SERVICE BULLETIN

INSPECTION OR REPLACEMENT OF THE ROCKER ARMS AND VALVE PUSH-RODS FOR ROTAX® ENGINE TYPE 912 AND 914 (SERIES)

SB-912-035 R1

SB-914-021 R1

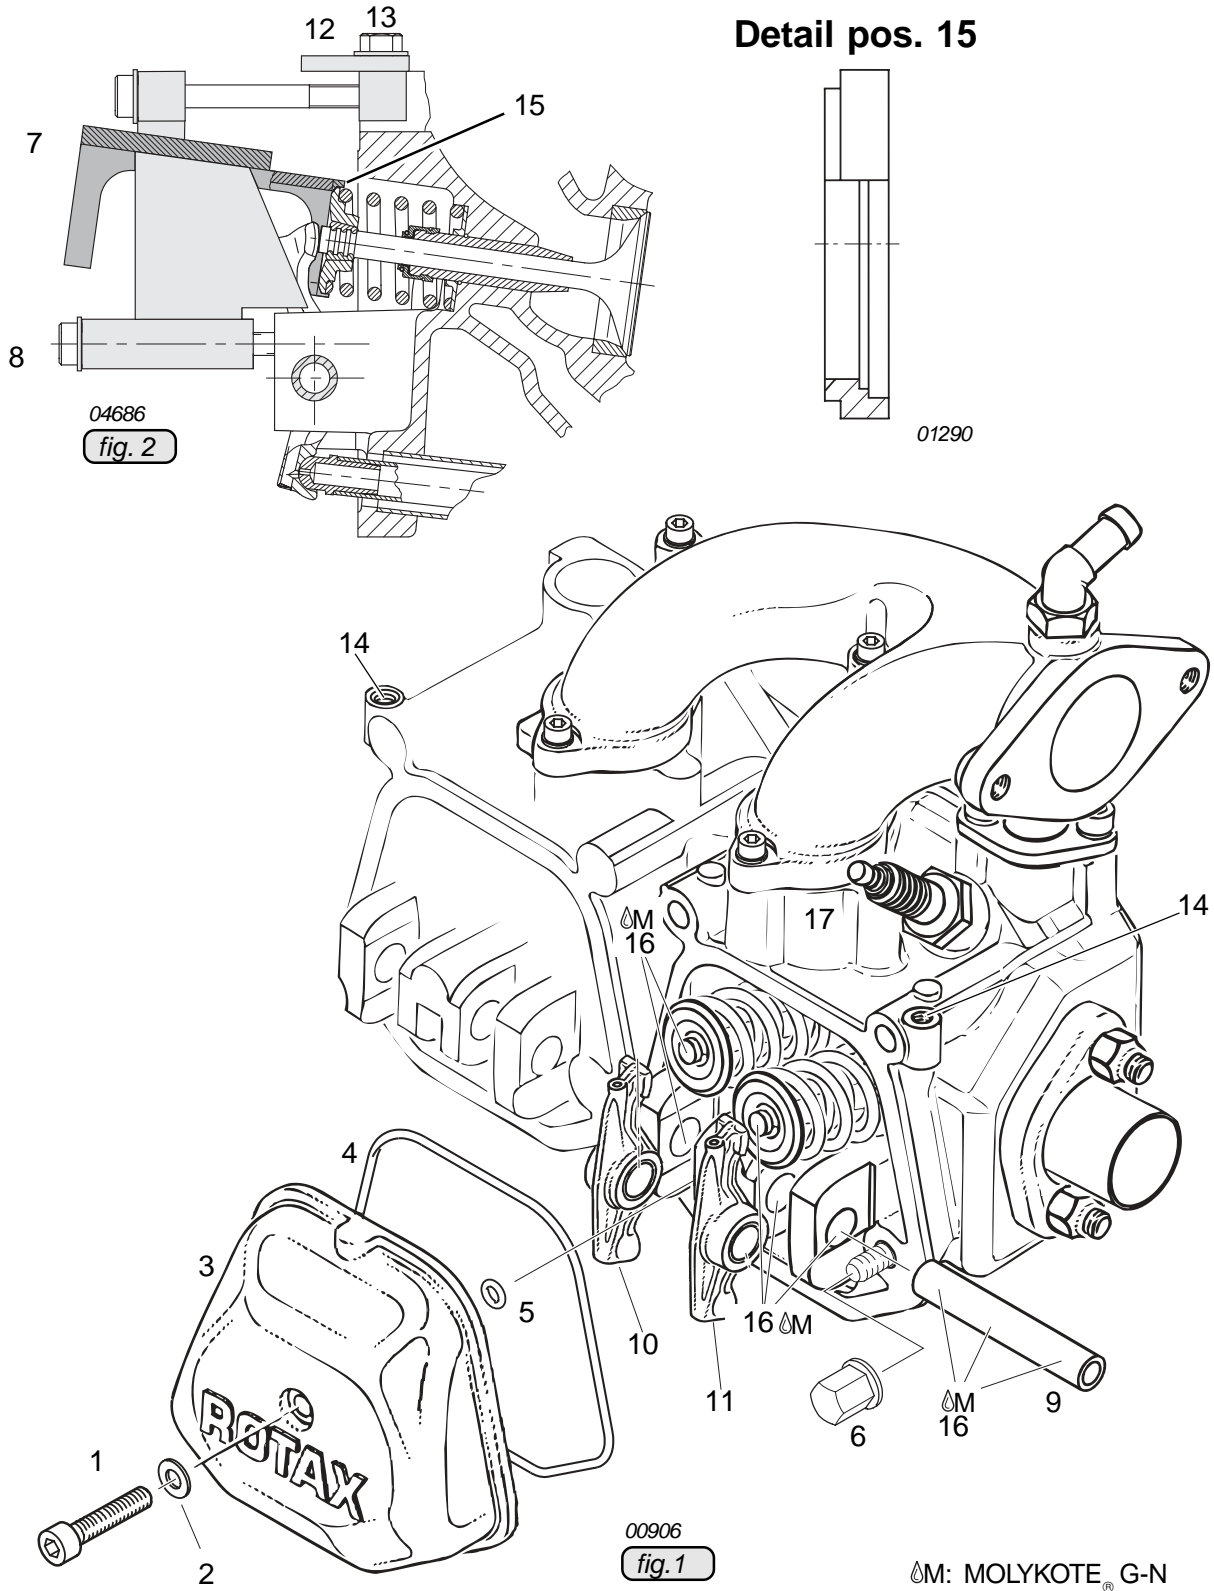
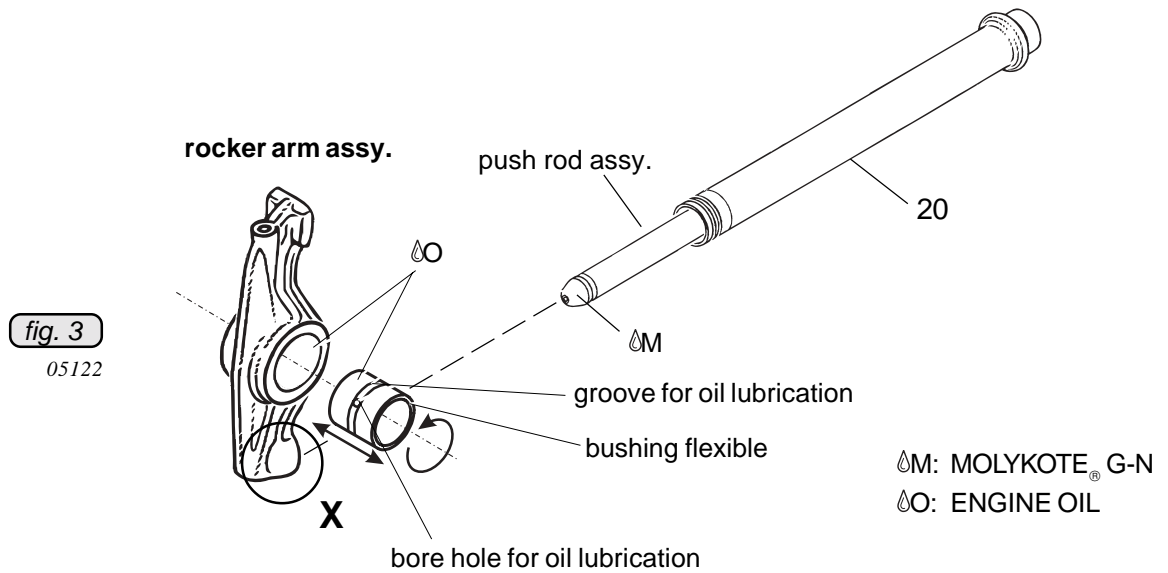
- Loosen Allen screw (1) M6x30 with washer (2) from valve cover (3), and remove it together with large and small O-rings (4) and (5).
- Turn crankshaft so that the respective piston is exactly on ignition top dead center. Loosen the external cap nut (6).

- Attach the support plate (12) to the valve spring loading jig (7) with 2 hex. screws (13) M6x16 at the attachment points (14) on the cylinders.
- Put adapters (15) on the valve spring loading jig.
- Attach the valve spring loading jig on cylinder head and support plate with 2 Allen screws (8) M6x70 and depress both valves with 3 turns.

- This will relieve both hydraulic tappets. Now the rocker arm shaft (9) may be easily pulled out. Lift out both rocker arms (10) and (11).

- Apply MOLYKOTE[®] G-N M(16) on both push-rod ball joints and contact areas of rocker arm and slide push-rod into the oil return tube (20).

- Place inlet rocker arm (10) and outlet rocker arm (11) in cylinder head, apply MOLYKOTE[®] G-N (16) on rocker arm shaft (9) and insert it into its bearing support.

- Mount collar cap nut (6) (tightening torque 22 Nm (197 in.lb)).

- Insert new O-ring (4) 105x2,5 and O-ring (5) 6,4x1,8 into the valve cover (3).

- Tighten the new Allen screw (1) M6x30 with washer (2) to 10 Nm (88 in.lb).

fig. 4 **Detail X**

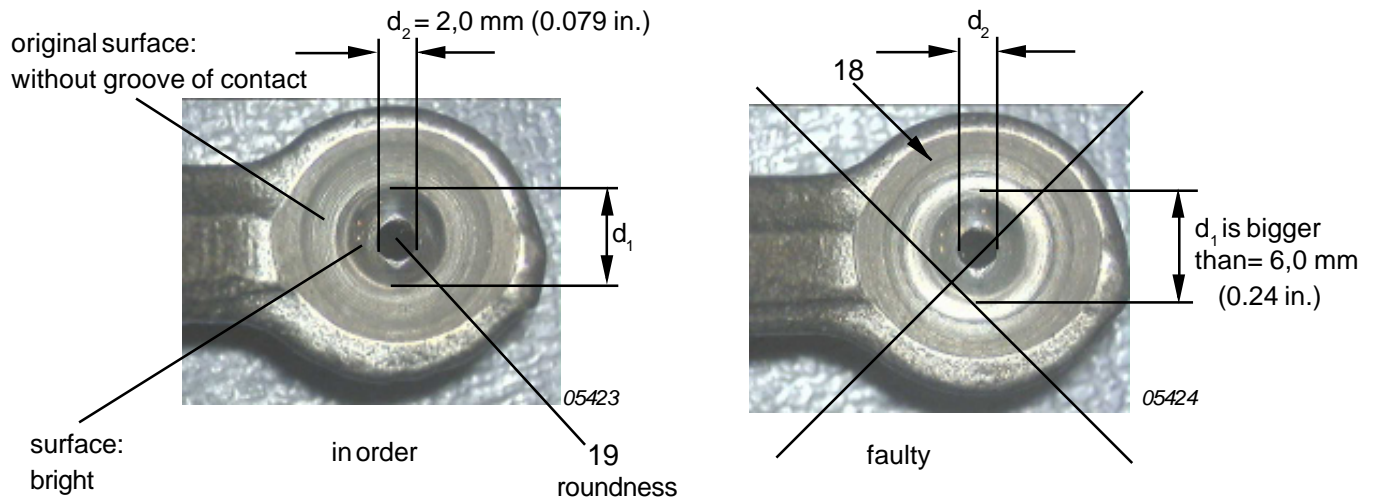
◆ **NOTE:** Detailed visual inspection particularly in the rocker arm ball joint (female) area. See fig. 4.

- Inspect rocker arm ball joint (female) (18). Traces of wear on the rocker arms are noticeable by geometric changes of the spherical form and smoothed areas in the ball joint shine brightly. Should the engine not have been running for more than one month, then the shining part may become dull again. The diameter of the smoothed running surface, measured by a sliding caliper (or equivalent) along the rocker arm axis, shall not exceed a value of $d_1=6,0$ mm (0.24 in.). Inspect lubricating bore (19) $d_2= 2,0$ mm (0.079 in.) for roundness. The roundness tolerance must lie within 0,2 mm (0.0079 in.). Any tendency towards an oblong hole is not permissible.

- Should one of these criteria be encountered, replace the appropriate rocker arm **and** its associated push-rod.
